## SERVICE INFORMATION NO. SI 42-082

GARMIN – Service Bulletin No. 0823  
ATA-Code: 34-00

**NO.: 0823**

**SUBJECT:** GDU 104X CRS/BARO Knob Interference

**Figure 1**

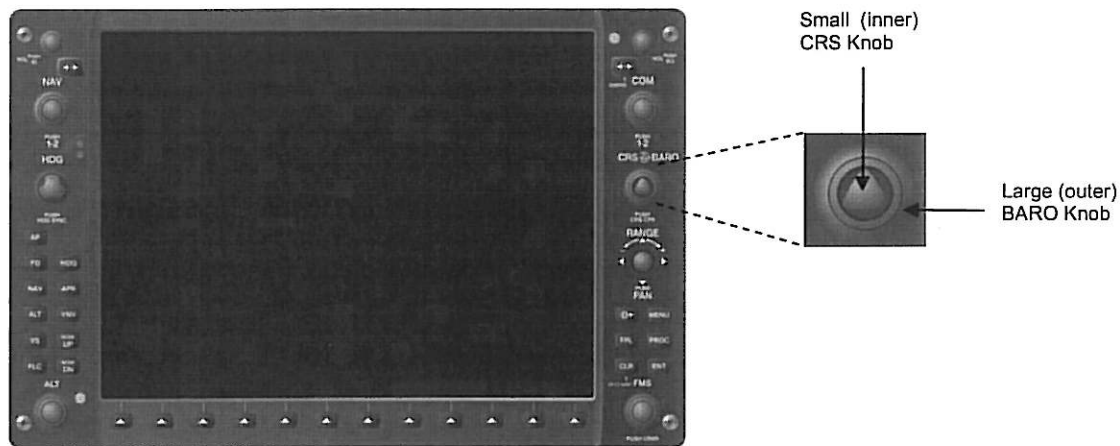
Garmin has identified an issue, whereby the large (outer) BARO knob and the small (inner) CRS knob may interfere with each other.

1. Apply power to the G1000/G900X/G950.
2. Press the CDI softkey on the Primary Flight Display(s) (PFD) to enter VOR mode on the HSI.
3. Rotate the large (outer) BARO knob (refer to Figure 1) a minimum of three complete revolutions in each direction while monitoring the Horizontal Situation Indicator/Digital Course Indicator (refer to Figure 2) on the PFD. If a change in the Horizontal Situation Indicator/Digital Course Indicator is produced while turning the BARO knob proceed to the Modification Instructions.

4. Rotate the small (inner) CRS knob (refer to Figure 1) a minimum of three complete revolutions in each direction while monitoring the Barometric Altimeter Setting (refer to Figure 2) on the PFD. If a change in the Barometric Altimeter Setting is produced while turning the CRS knob proceed to the Modification Instructions.
5. Repeat Steps 3 and 4 for each affected GDU.

**Figure 3**

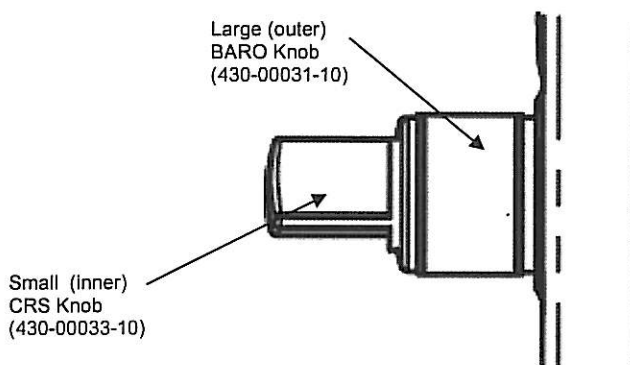
5. Grasp the large (outer) BARO knob (insuring proper orientation) and place it over the shaft.
6. Align the flat side of the knob insert with the flat side of the shaft.
7. Press down firmly to ensure knob is completely seated, refer to Figure 3.
8. Grasp the small (inner) CRS knob (insuring proper orientation) and place it over the shaft.
9. Align the flat side of the knob insert with the flat side of the shaft.
10. Press down firmly to ensure knob is completely seated, refer to Figure 3.
11. Perform the CRS/BARO Knob Interference Test (contained in the TESTING PROCEDURE section) again to confirm there is no interference.
12. Accomplish aircraft logbook entry to return aircraft to service in compliance with this service bulletin.
